Product Change Notification

Date Issued :	January 16, 2023	PCN Number :	513244
Reason for Change :	Change to Product		
Description of Change :	This notification is to inform you about changes that are being made to the part(s) as identified in the list based on the replacement of aged tooling at Molex Lincoln Nebraska. This change will not affect the Fit, Form or Function of the product but Will affect the Appearance of the product at the Locking Latch location.		
Assessment of Change :	First Article Inspection Reliability Test Report/s		
Planned Implementation Date :	July 17, 2023		
Sample Availability Date:	April 21, 2023		
Internal Molex Qualification Date :	May 19, 2023		
Last date to request Samples by Customer :	June 30, 2023		
Traceability Code Markings / Date :	Cavity identification

- 5557 Series
- Mini-fit JR 3ckt receptacle

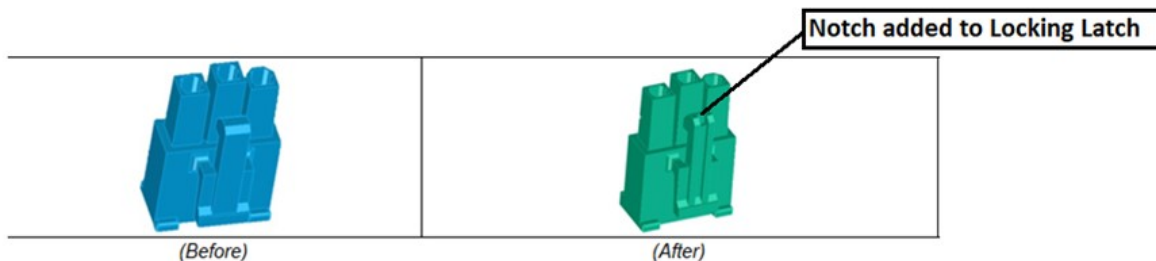
- To ensure business continuity, Molex Lincoln Nebraska is needing to replace tooling for the Mini-Fit Jr 3ckt receptacle due to the age of the current tool.
 - New tooling will be changed to improve mold flow during part production
 - Product from the New tooling from Lincoln Nebraska will have a notch added to the Locking Latch
 - Notch in Locking Latch is to improve mold flow and reduce short fill of product
 - Product made from other locations will not have this notch
- Change will impact Appearance of the part at Locking Latch location
- There will be NO change to the Fit, Form or Function of the parts
- Part Numbers Impacted
 - See attached list
- Qualification and Samples available upon request after date shown above
